**CITY OF MERIDIAN
FINDINGS OF FACT, CONCLUSIONS OF LAW
AND DECISION & ORDER**

In the Matter of the Request for Modification to the Existing Development Agreement (Inst. #110115738) to Replace it with a New Agreement for the Proposed Development; Rezone of 7.06-Acres from the C-C to the H-E Zoning District; 17.38-Acres from the C-C & H-E Zoning Districts to the M-E Zoning District; and 40.33-acres from the R-40, C-C and M-E Zoning Districts to the R-15 Zoning District; and 1.10-Acres from the H-E to the C-C Zoning District; Preliminary Plat Consisting of Eight (8) Building Lots & Six (6) Common Lots on 115.26-Acres of Land in the R-15, C-C, H-E and M-E Zoning Districts for Vanguard Village Subdivision; and, Conditional Use Permit for a Multi-Family Development Consisting of 552 Dwelling Units on 40.33-Acres of Land in the R-15 Zoning District for Vanguard Crossing, by Insight Investment Partners.

Case No(s). H-2021-0081

For the City Council Hearing Date of: April 19, 2022 (Findings on May 3, 2022)

1. Preliminary Plat & Phasing Plan (REVISED) (date: 11/17/2021)

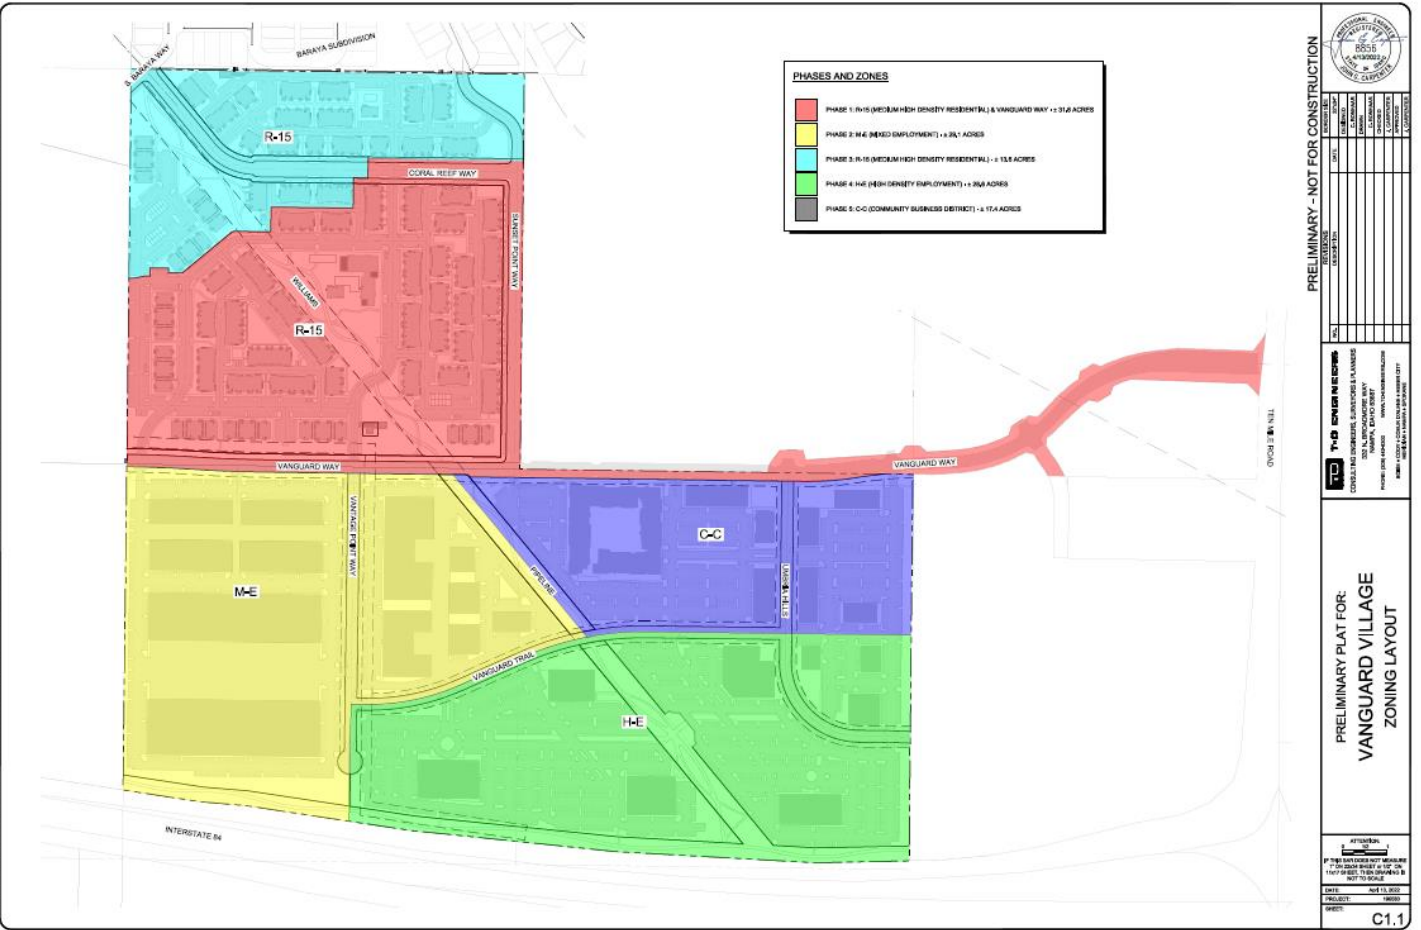
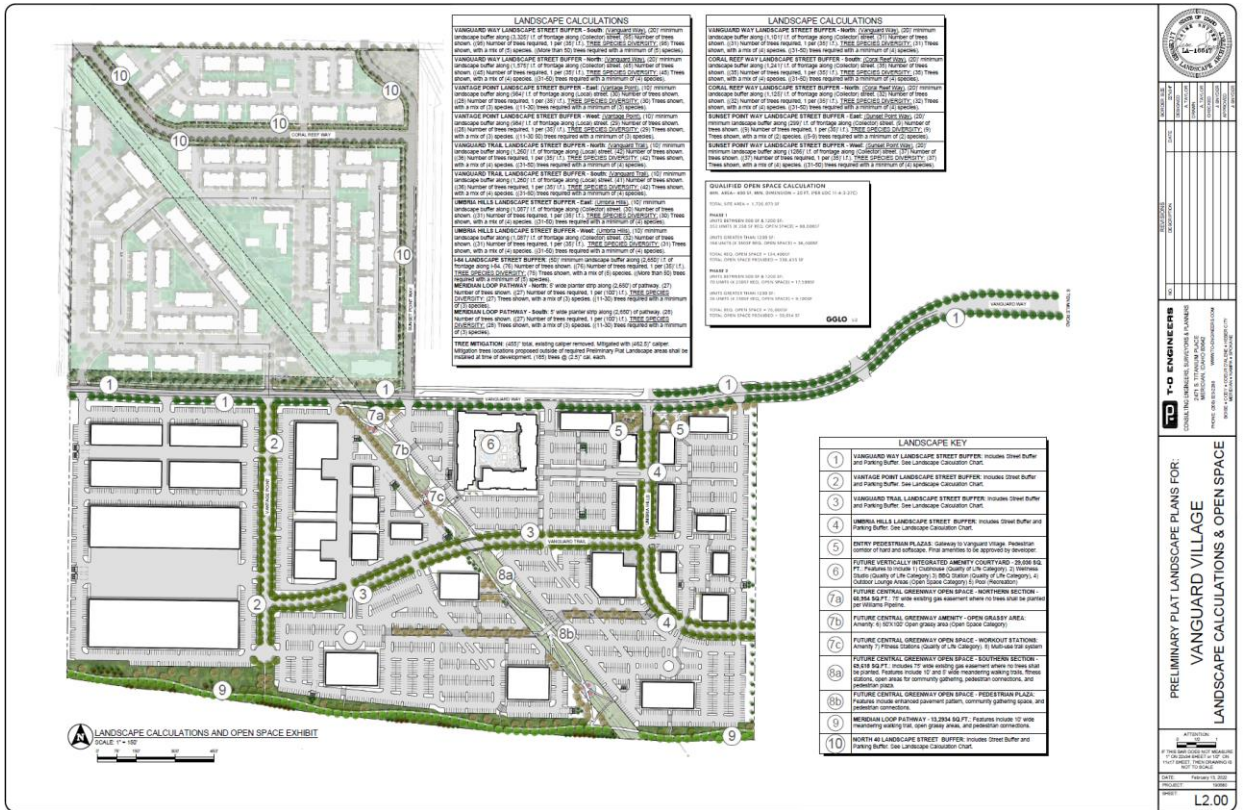
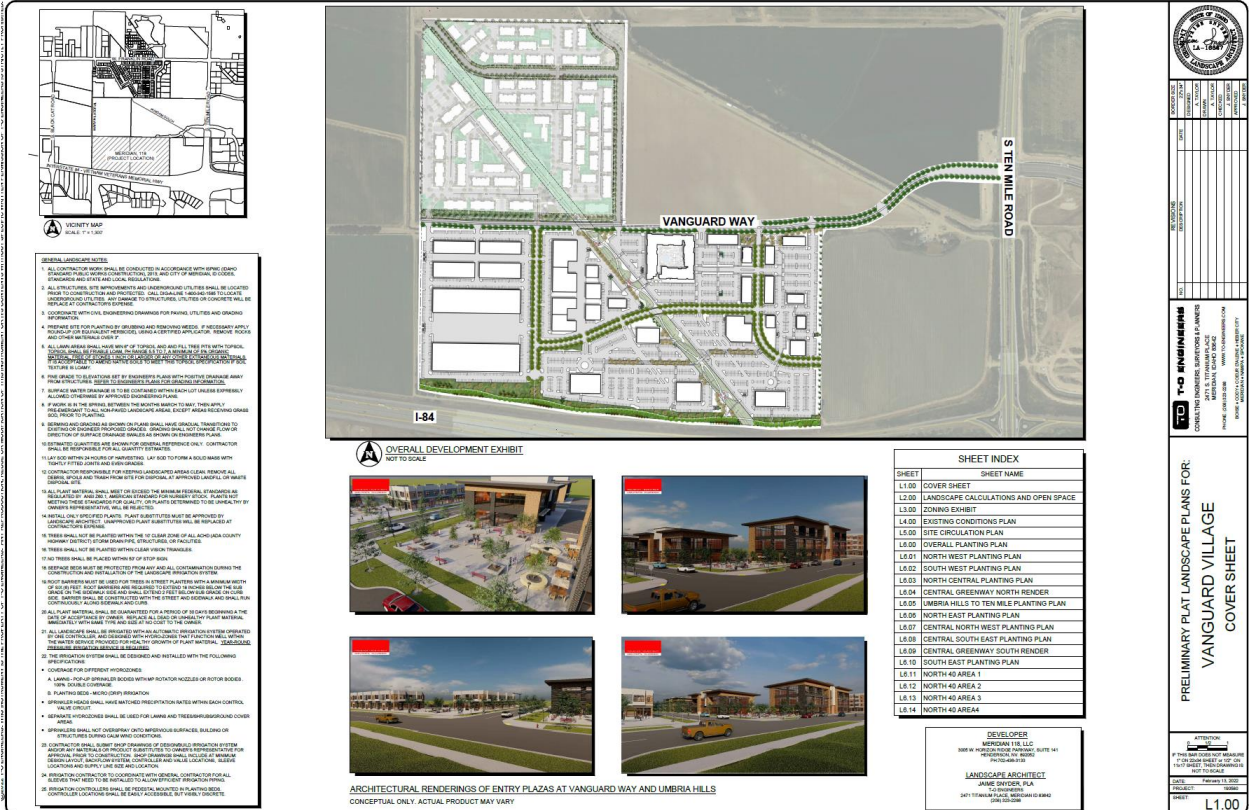
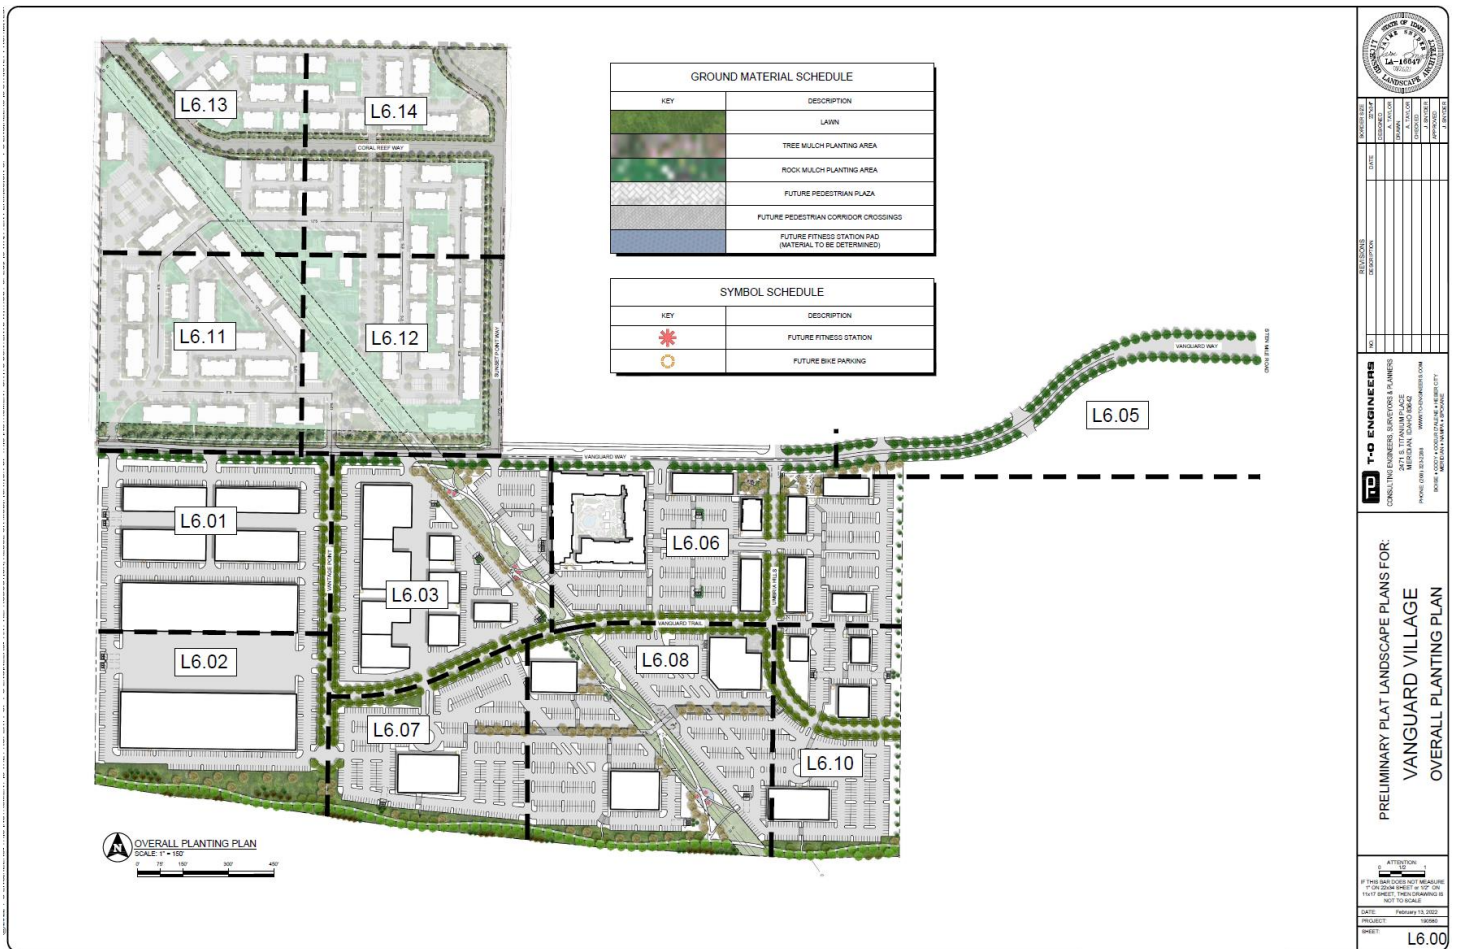
sidewalks (see pg. 3-21 and 3-23). Streetlights should be placed in the dry utilities' corridor on either side of the street. **The plat should be revised consistent with Street Section D.**

- c. Depict street sections for Sunset Point Way and Coral Reef Way consistent with Street Section D in the TMISAP (see pg. 3-21).
- d. Depict street sections for Vanguard Way and Umbria Hills consistent with Street Section C in the TMISAP with a modification that allows (3) 11-foot travel lanes, on-street parking between the Williams pipeline and the eastern boundary of the site, 8-foot parkways and detached 10-foot wide sidewalks/pathways in lieu of on-street bike lanes as required by ACHD. Streetlights are required at a pedestrian scale (see pg. 3-20, 3-22, 3-23).

2. Landscape Plan (date: 2/13/2022)

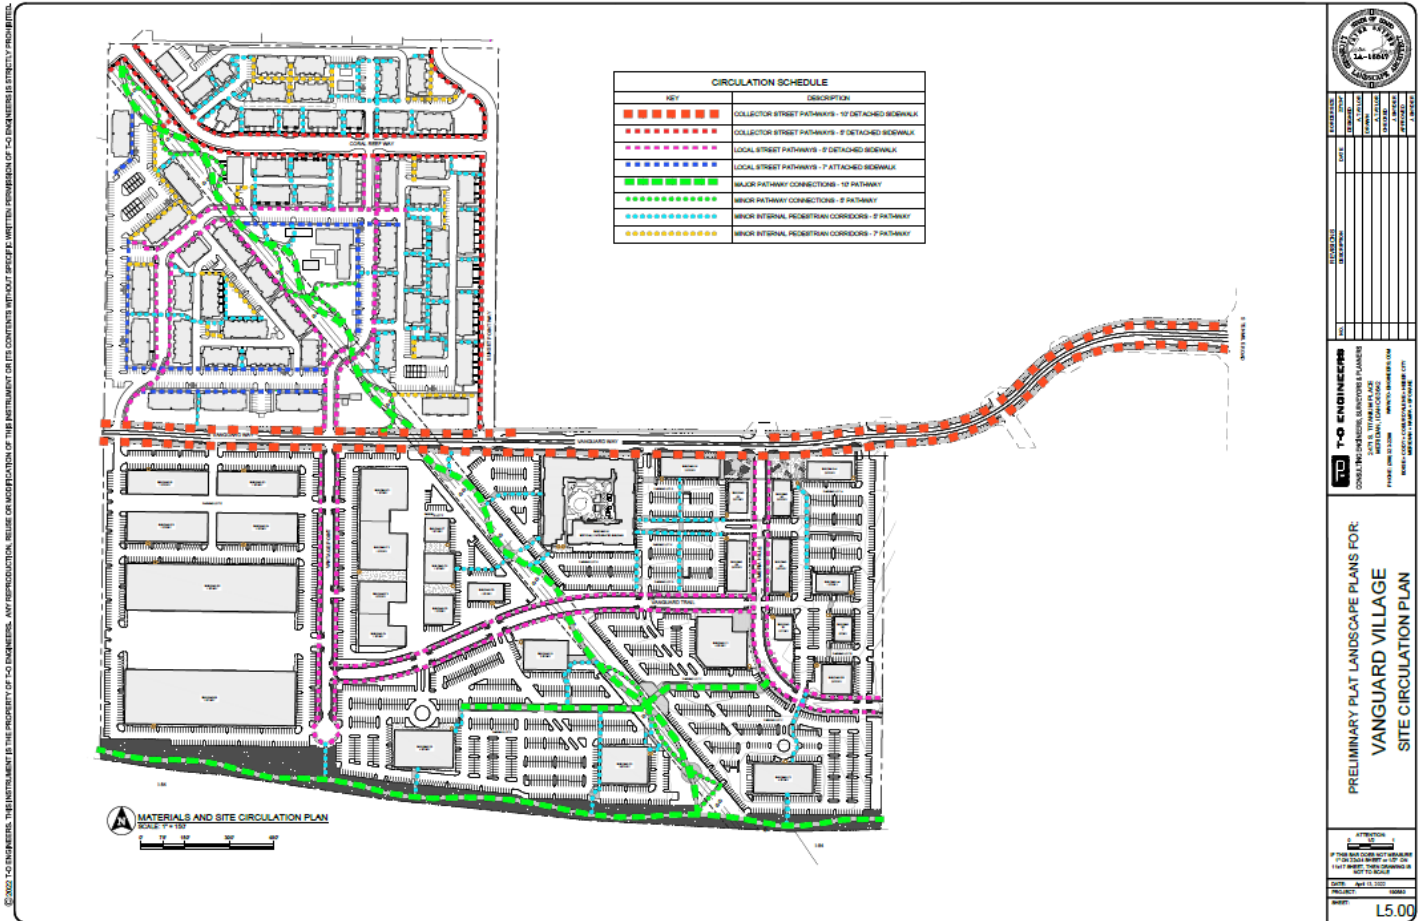
Landscaping is required within parkways per the standards listed in UDC [11-3A-17](#) and [11-3B-7C](#). **Class II trees shall be provided in parkways in accord with UDC 11-3A-17E; Class III trees may be considered if the parkways are widened to 10 feet – revise the landscape plan accordingly.**

Landscaping is required along all pathways per the standards in UDC [11-3B-12C](#). A 5' wide landscape strip is required on both sides of the pathway planted with a *mix* of trees, shrubs, lawn and/or other vegetative ground cover. **If trees are not allowed within the pipeline easement, an additional 5-feet should be added to the common area outside of the easement to allow for trees; or, alternative compliance may be requested to the planting requirement.**

Mitigation is required for all existing trees 4" caliper or greater that are removed from the site in accord with the standards in UDC 11-3B-10C.5. Mitigation calculations are depicted on the landscape plan in accord with UDC standards (i.e. 185 trees at 2.5 caliper inches each for a total of 462.5 caliper inches). **The location of mitigation trees shall be depicted on a revised landscape plan submitted with the final plat application.**

2.3 The landscape plan submitted with the final plat shall be revised as follows:

- h. Mitigation trees shall be depicted on the plan (185 trees at 2.5 caliper inches each for a total of 462.5 caliper inches).
 - i. If trees are not allowed within the pipeline easement, an additional 5-feet should be added to the common area outside of the easement to allow for trees; or, alternative compliance may be requested to the planting requirement for pathways and open space.

1. Site Plan (dated: 10/6/21)

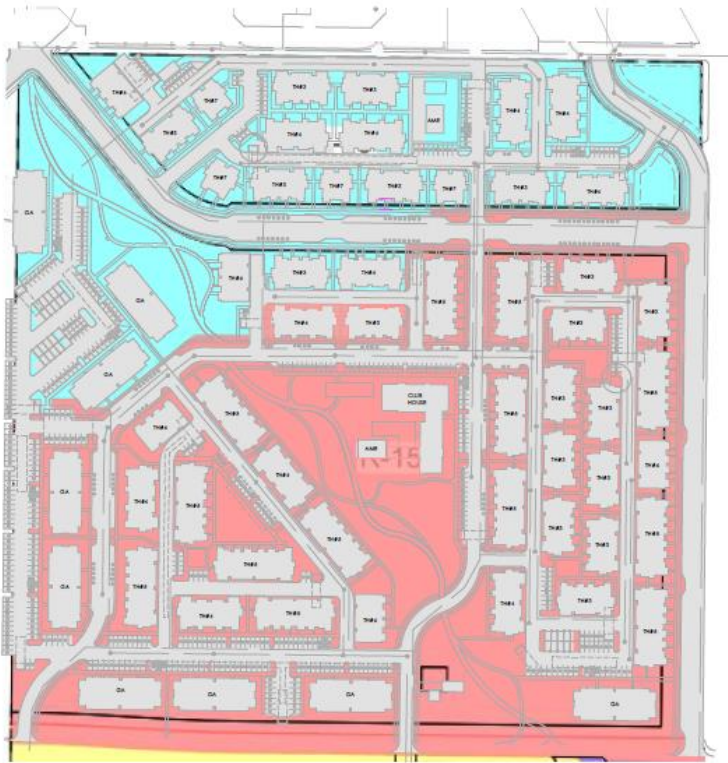
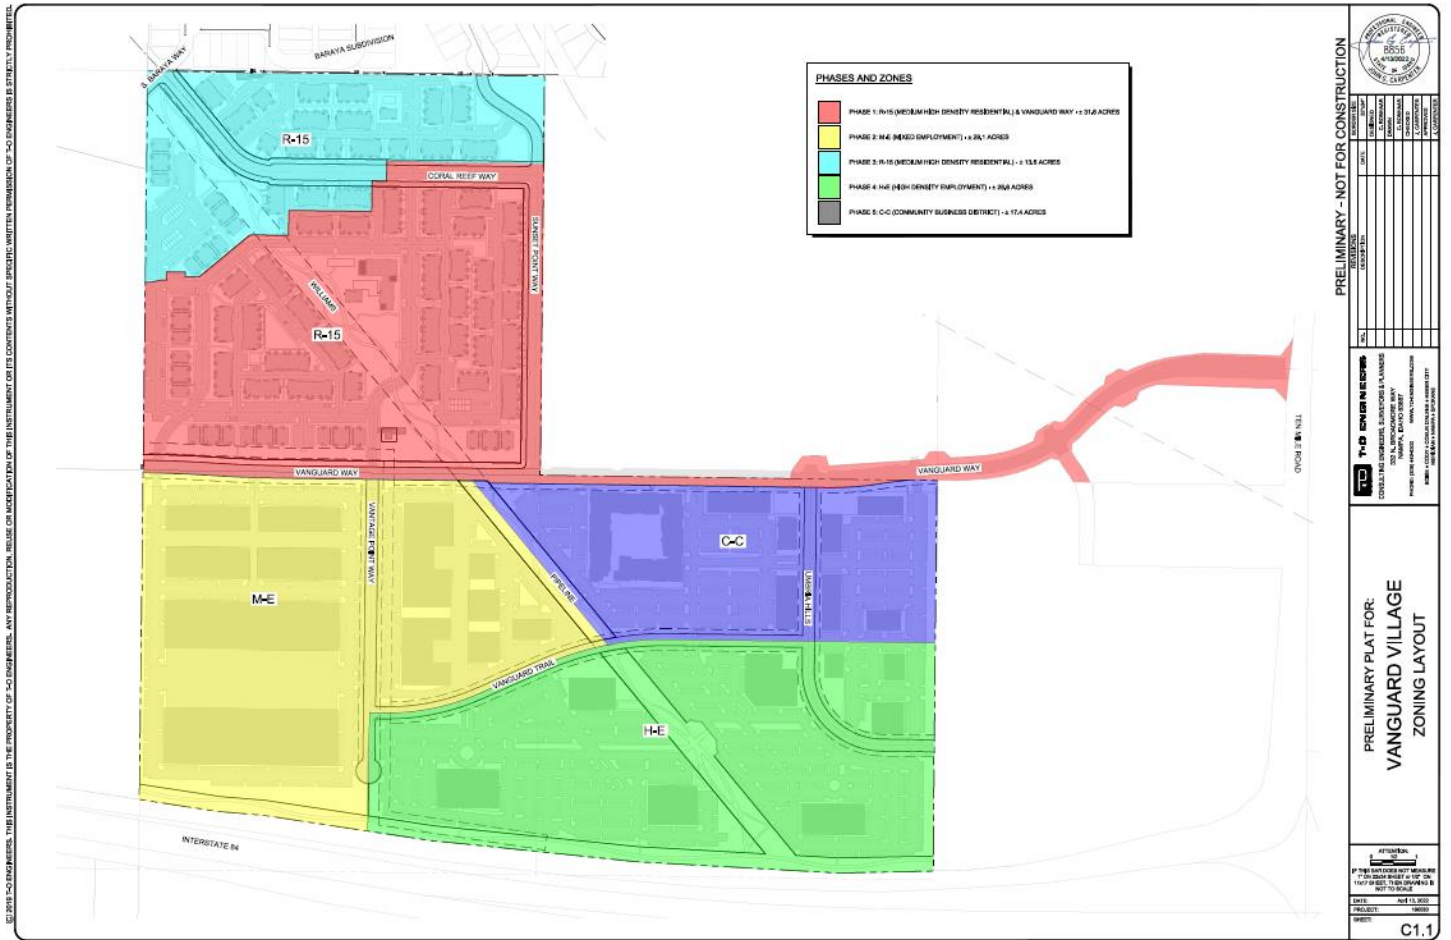
*A leasing office, storage area, and a mail & parcel center are depicted on the clubhouse floor plan. **The location of the directory and map of the development shall be noted on the site plan submitted with the Certificate of Zoning Compliance application.***

- 3.1 Comply with the specific use standards listed in UDC 11-4-3-27 for multi-family developments, including but not limited to the following: (revise the site plan and/or landscape plan accordingly)
- a. All on-site service areas, outdoor storage areas, waste storage, disposal facilities, and transformer and utility vaults shall be located in an area not visible from a public street,

- c. Depict the location of the property management office, maintenance storage area, and central mailbox location (including provisions for parcel mail) on the site plan that provides safe pedestrian and/or vehicular access and the location of the directory & map of the development at an entrance or convenient location for those entering the development as set forth in UDC [11-4-3-27B.7](#).

- 3.2 Include a detail for the bicycle parking facilities that complies with the standards in UDC [11-3C-5C](#). Bicycle racks should be depicted in central locations for each building and for the clubhouse.
